Re: Soil and Groundwater Investigation Work Plan Addendum
Atlantic Richfield Company Service Station #498
286 South Livermore Avenue, Livermore, California
ACEH Case No. RO0002873

Re: Soil and Ground-Water Investigation Work Plan Addendum, Atlantic Richfield Company
(a BP affiliated company) Station #498, 286 South Livermore Avenue, Livermore,
California. Case No. RO0002873.

Provided herein is an addendum to Broadbent and Associates, Inc. (BAI) August 28, 2009 *Soil and Ground-Water Investigation Work Plan* (herein referred to as the Work Plan). In response to the Work Plan, Alameda County Environmental Health (ACEH) issued the February 10, 2010 letter stating that justification for the proposed monitoring well locations for MW-6 and MW-7 is needed in order to adequately characterize the off-site groundwater contaminant plume. The letter also recommended that direct push borings be used for characterization rather than the installation of permanent monitoring points.

Attachment: Drawing 1: Site Map with Historic Sample and Proposed Well/Boring Locations

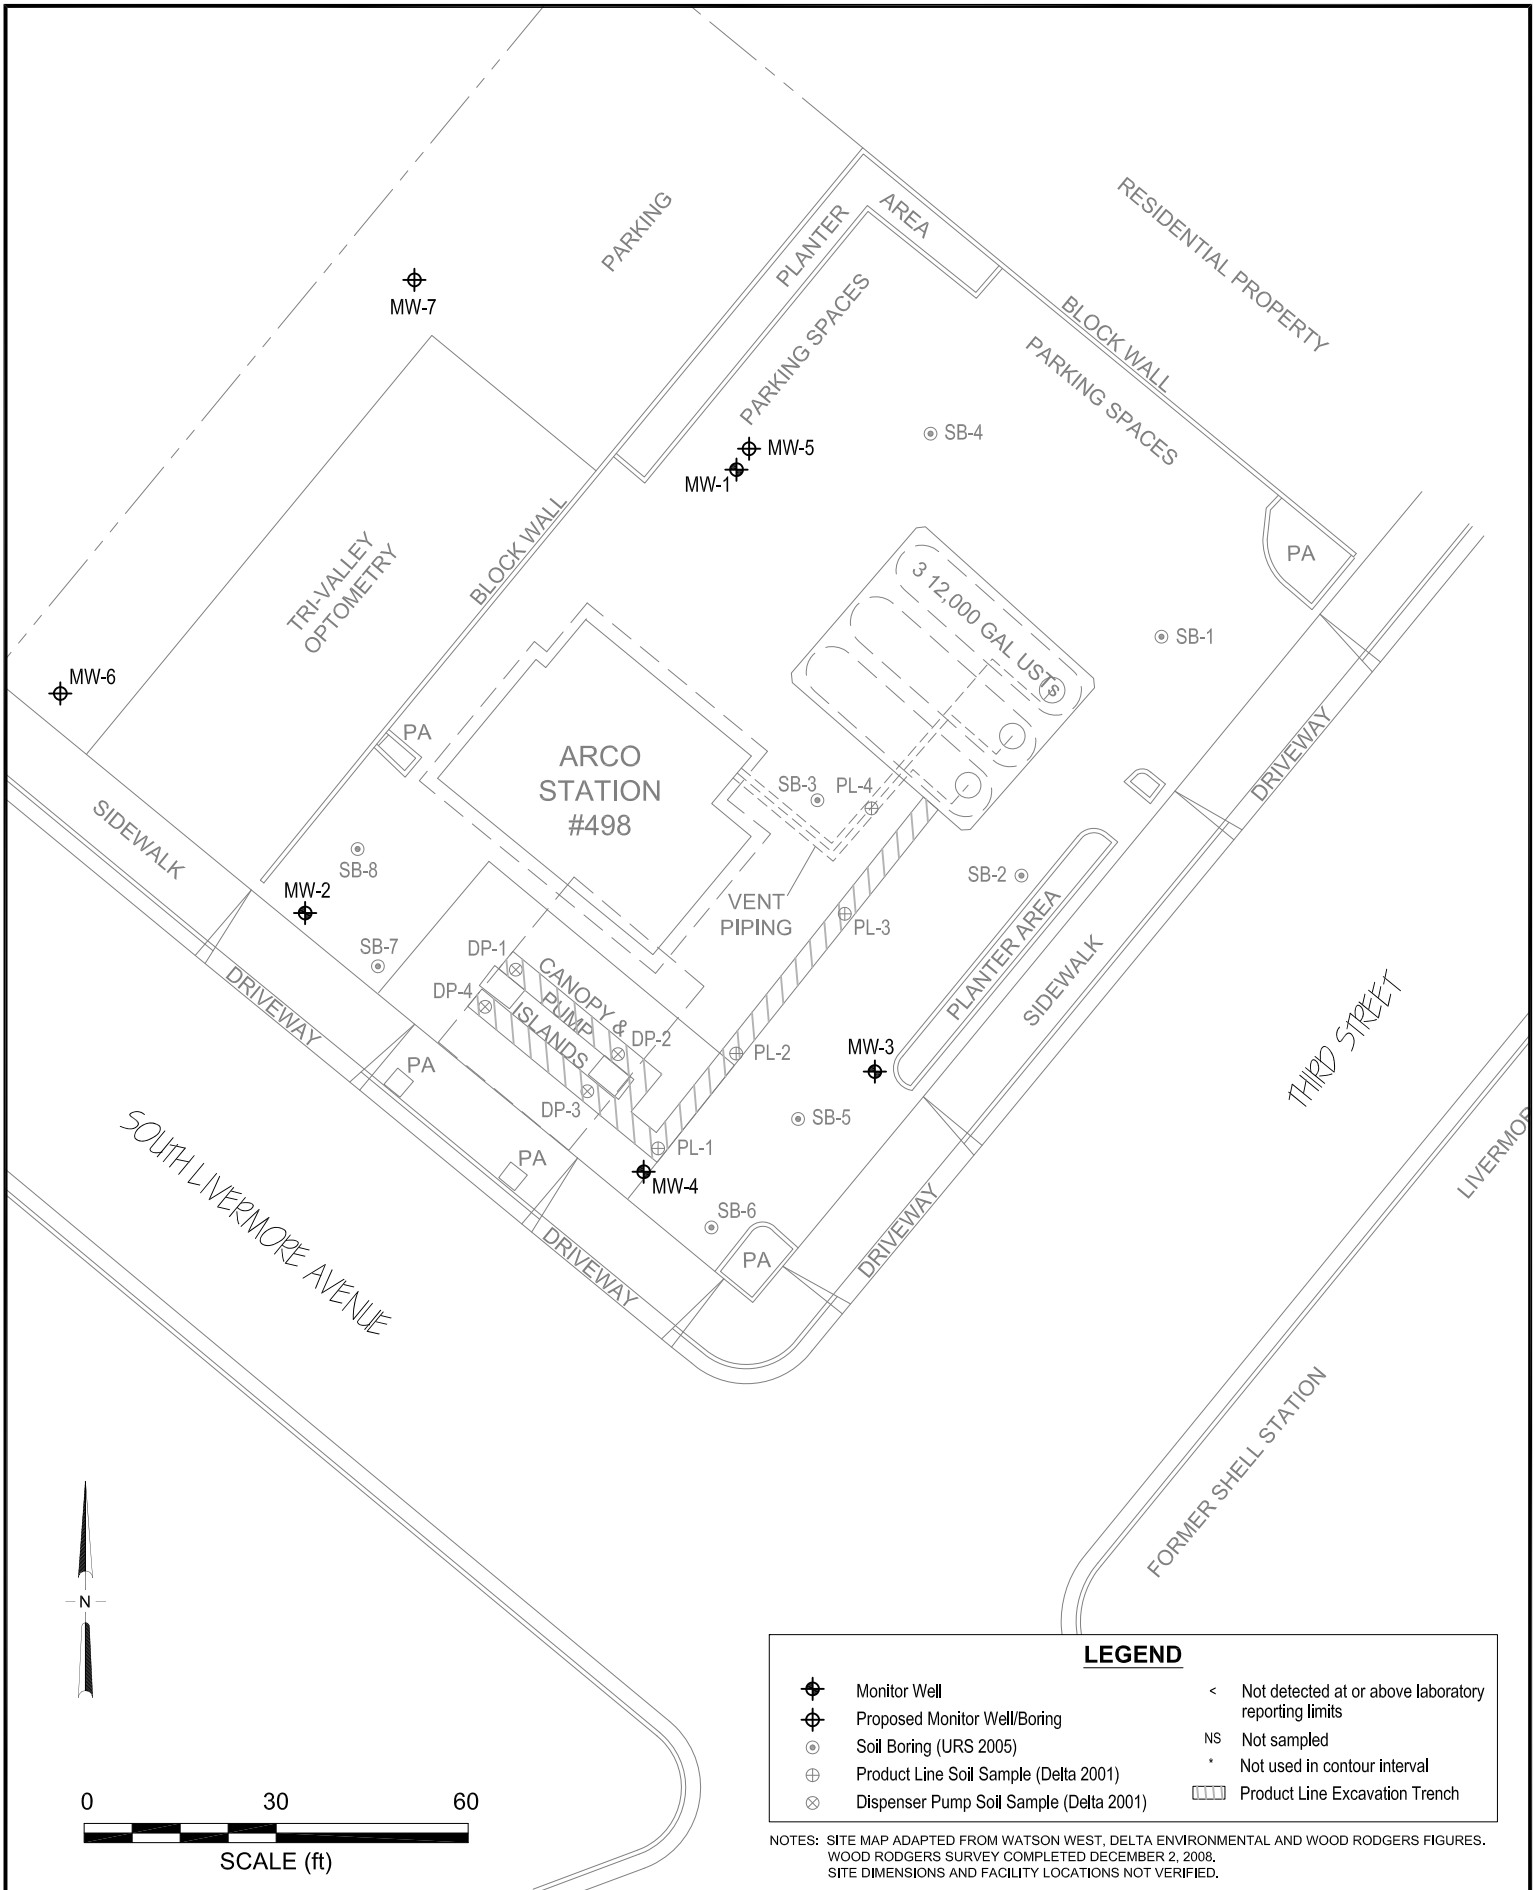
The location chosen for the installation of proposed monitoring wells MW-6 and MW-7 coincides with flow directions measured at the former Shell Station located across 3rd Street and from data collected on the Property during the First Quarter 2009 groundwater monitoring event, which both indicate a northwesterly flow direction. The flow direction calculated from data collected on November 9, 2009 during the Fourth Quarter 2009 monitoring event improperly utilized the groundwater elevation measured in well MW-1, which appears to be anomalous and possibly screened across a localized perched groundwater zone. Proposed well MW-5 will be installed adjacent to existing well MW-1 in order to determine the possible presence of a perched water bearing zone. Based on this data, the previously proposed locations for wells MW-6 and MW-7 should adequately characterize the potential migration of an off-site groundwater contaminant plume. A site map depicting the proposed well and/or boring locations is included as Drawing 1.

As discussed in the original Work Plan, difficult drilling conditions encountered during completion of the 2005 investigation rule out the use of a direct push drilling technique and collection of grab ground-water samples. In order to comply with ACEH's recommendations, it is still proposed to utilize a hollow stem auger drill rig for the collection of groundwater samples and/or well installation to avoid potential refusal. However, it is proposed to abandon the off-site borings rather than conduct permanent well installations if photo-ionization detector (PID) readings taken from soil samples collected at approximate five foot intervals do not indicate the presence of hydrocarbon impacts. If the soil sample PID readings demonstrate the presence of impacted soil, a permanent groundwater monitoring well will be installed as described within the Work Plan at each location. If impact is not detected in the soil via PID readings, the abandoned borings will be sealed with neat cement grout and completed to match existing surface surroundings.
